# Environmental Assessment Report

## Centre Pit Expansion

*Savage River Mine*

## Environmental Assessment Report

**Figure 3: Centre Pit oblique section showing saturated CPN and northern end of CPS water body (altered Figure 44 of the EIS).**

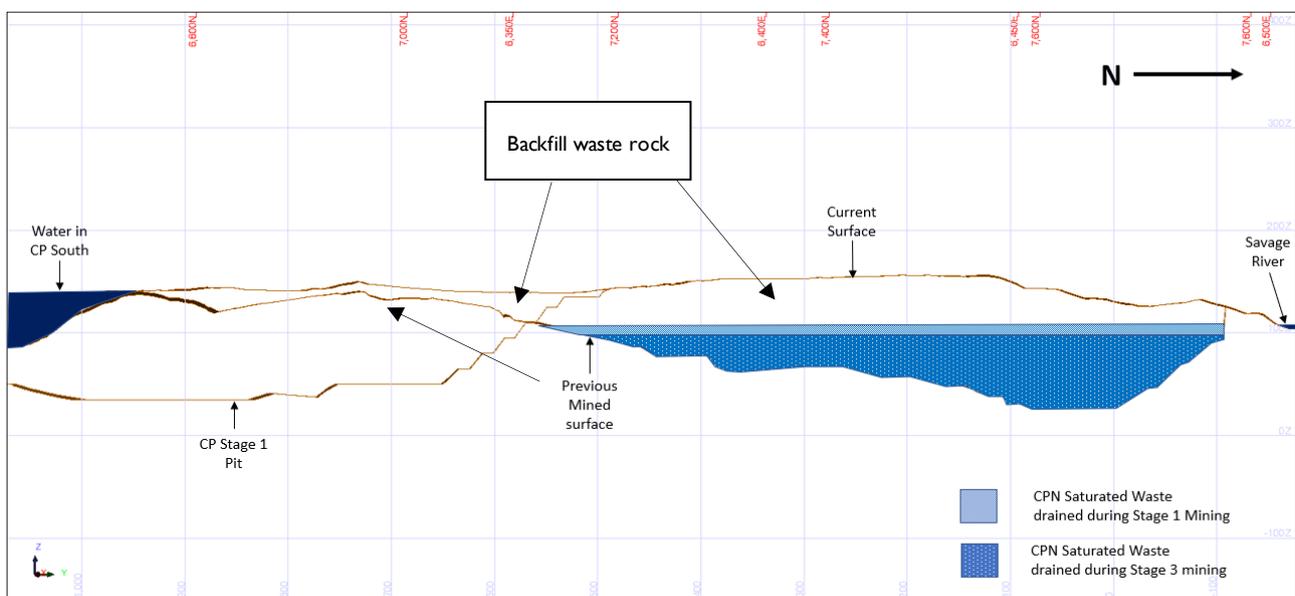
Note, Appendix C also refers to water contained within the waste rock in CPN draining southward to CPS pit once the groundwater level in CPS is drawn down. While it is understood that the topographic divide between the two pits is at 135 m RL, detail of the topography and likely groundwater flow between the two pits is not clearly understood from Figure 44 of the EIS, nor the text.

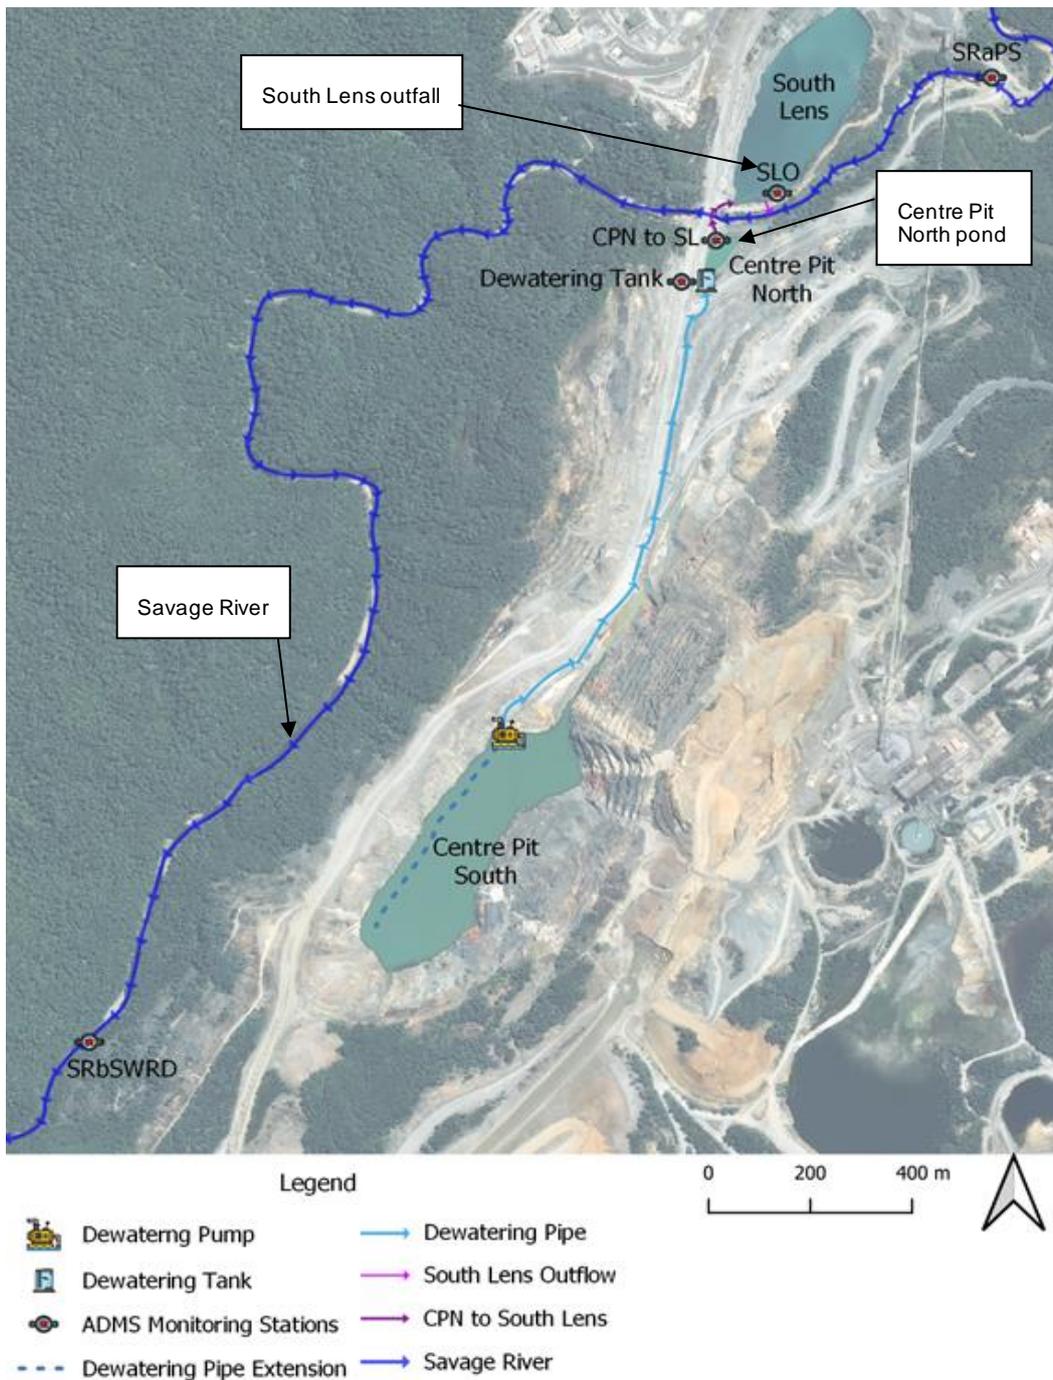
Furthermore, the proximity of the CPN pond inflow point to the South Lens discharge point (Figure 4) may also result in an element of short circuiting, which could reduce the neutralisation and precipitation of metals from the CPN pond discharge.

Condition **EM3** also requires that monitoring at CPN pond is increased to 2/week should a water quality trigger value be exceeded at this location. While it is recognised that the South Lens outflow is the critical response location, being the discharge point to the environment, the increase in monitoring at CPN pond will allow for a better understanding of the system and management response.

**Figure 5: South Lens outfall total copper concentration and flow rate (Figure 47 of the EIS).**

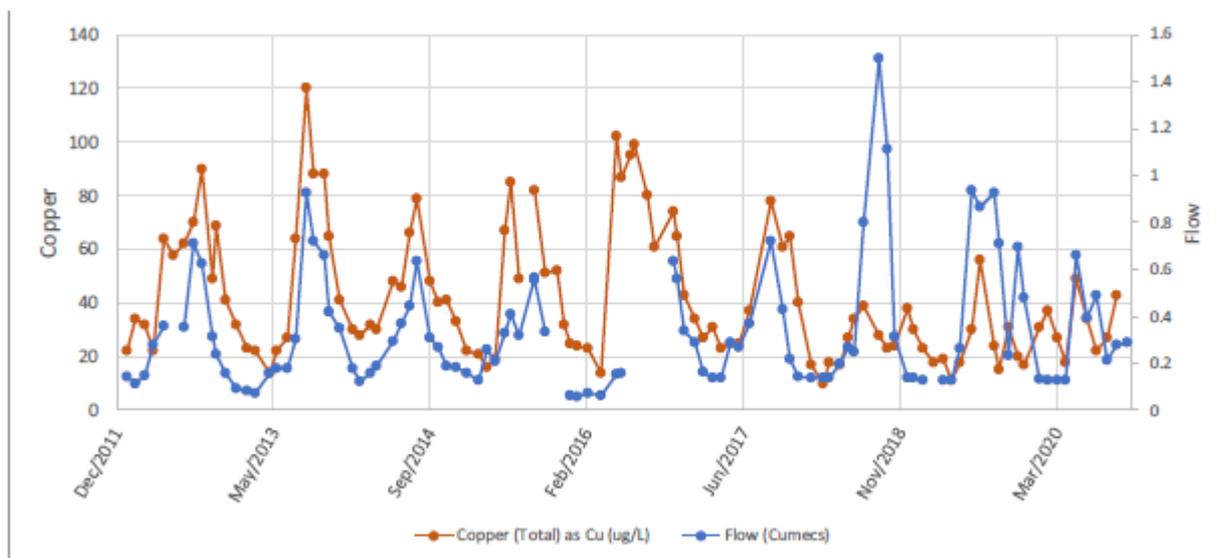
The EIS argues that the HRT within SL is no longer a key determining factor in driving metal reduction, due to the increased rate of metal removal brought about by the input of sediment laden alkaline waters (up to 600 L/s). Figure 47 of the EIS however suggests that such inflow may be greatly reduced (<100 L/s) during extended dry periods. Dependant on sedimentation and absorption dynamics within South Lens, the rate of metal removal may decrease during such periods, with HRT potentially becoming increasingly important for metal removal.
